**SANPARKS COMMENTS, PRE-APPLICATION DRAFT BASIC ASSESSMENT REPORT, RE of ERVEN 1339 AND 1316 KNYSNA, WESTERN CAPE**

**DDFE Ref No: 2026-01-0014 (Pre-Application)**

The application is a “**PRE-APPLICATION BASIC ASSESSMENT REPORT (BAR) FOR PROPOSED DEVELOPMENT OF KINETIC CATAMARANS INDUSTRIAL FACILITY ON ERF 1339, AS WELL AS DEVELOPMENT / REDEVELOPMENT OF THE SOUTH AFRICAN SEA CADET CORPS INFRASTRUCTURE ON ERF 1316, KNYSNA, WESTERN CAPE**”, refer to extracts below from the report prepared by Eco Route Environmental Consultancy, dated October 2025.

**Fig. 8.** A drainage channel runs through the testing ground and enters the estuary via a culvert.

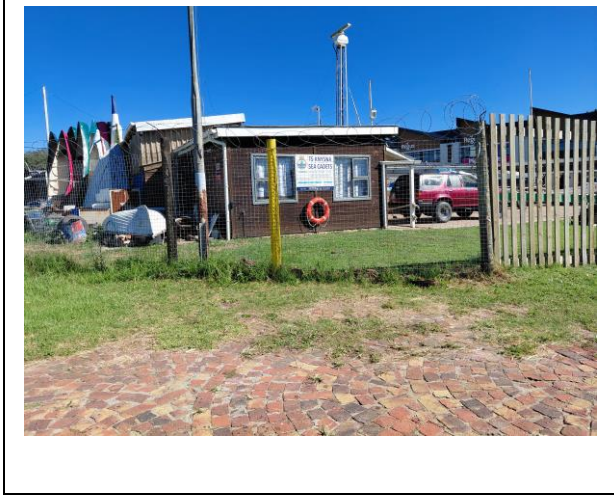
Extreme care would need to be exercised with the drainage channel that currently runs through the testing ground and enters the estuary via a culvert.

**Fig. 11:** Site Development Plan, MarkiTec, 1 April 2023

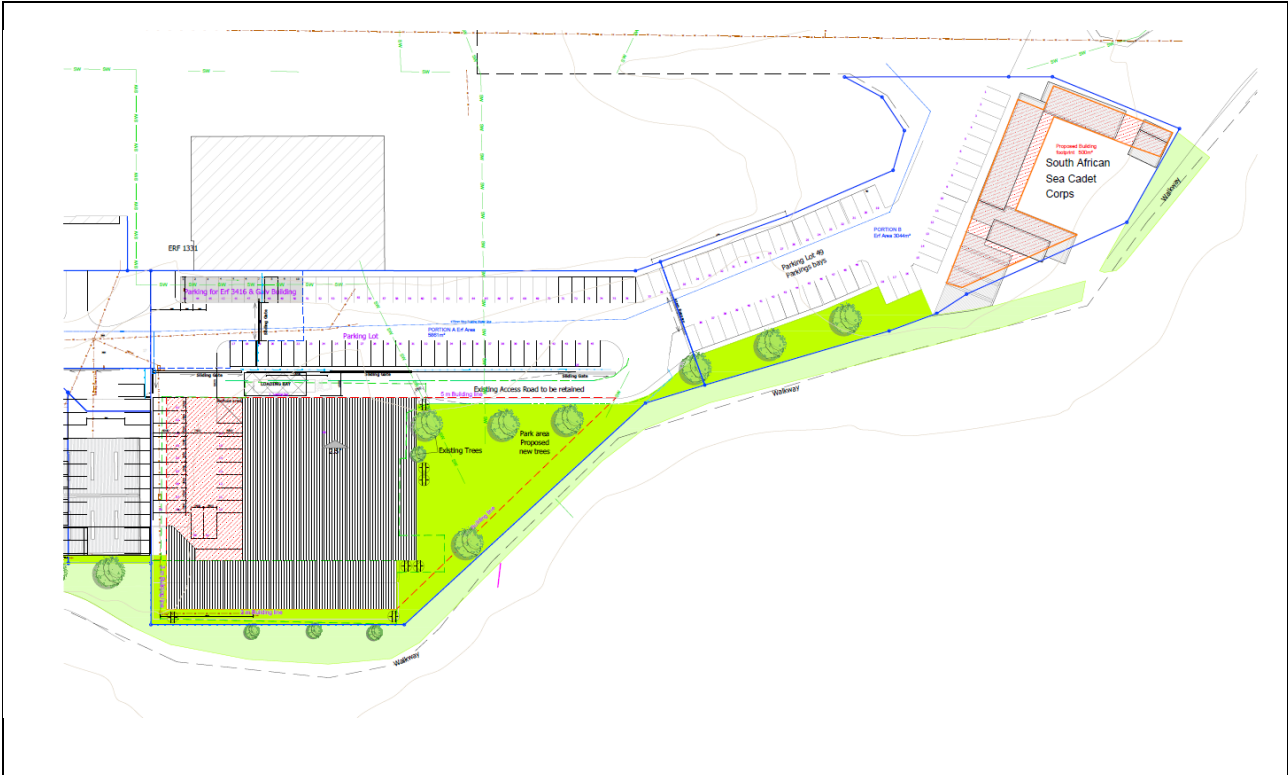
As the Kinetic factory and its proposed expansion area are situated directly adjacent to the Knysna Estuary, attention needs to be given toward ensuring that the estuary is not impacted by water quality, i.e., pollution, and quantity, i.e., stormwater runoff impacts.

SANParks requires sight of a Service Level Agreement with the Knysna Municipality, with assurance that sewage will be well managed and not pollute the Knysna Estuary.

Should the Knysna Municipality be unable to provide this assurance, it is suggested that the landowner investigate an alternative on-site, self-sufficient, non-polluting sewerage treatment facility, and/or an emergency sewage treatment option, in the event of a municipal sewerage treatment system failure.
